# Inner Walled City

### Options Report

Options report relating to issues raised by Royal National Institute of Blind People, the Guide Dogs for the Blind Association, IMTAC and Disability Action.

## Proposed Parking Provision & Kerb Upstand

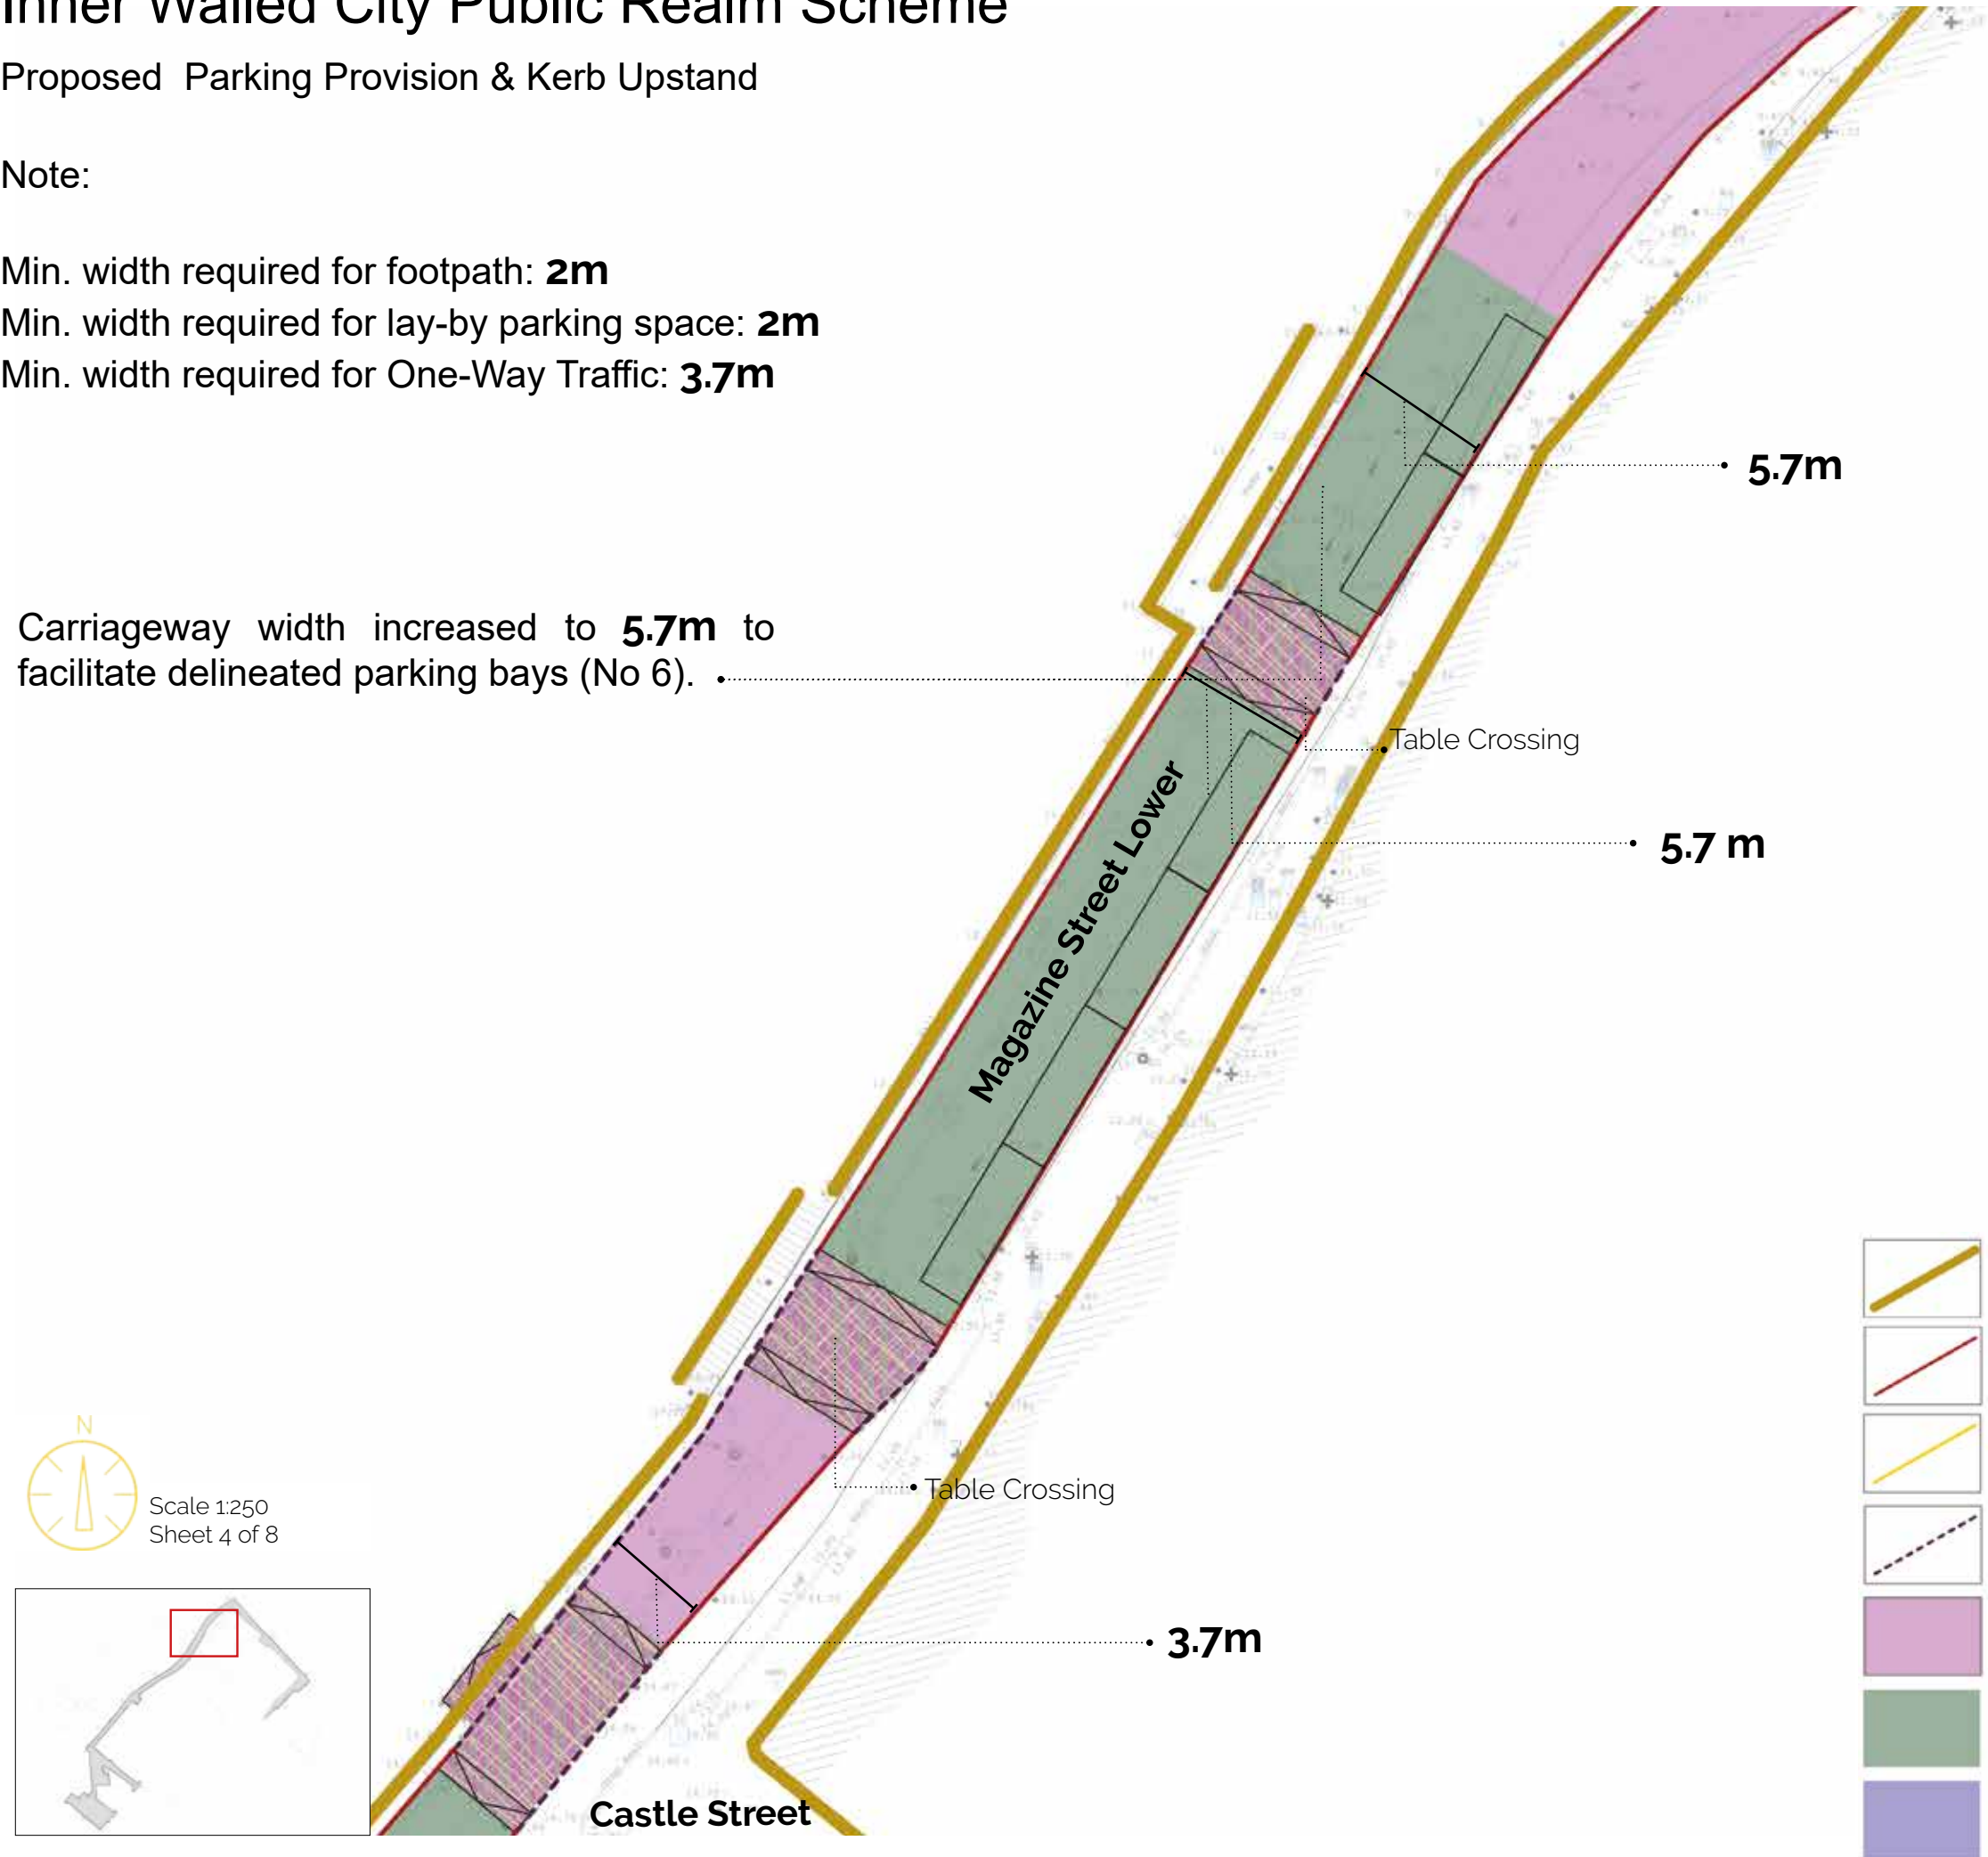
Carriageway width increased to **5.7m** to facilitate delineated parking bays (No 6).
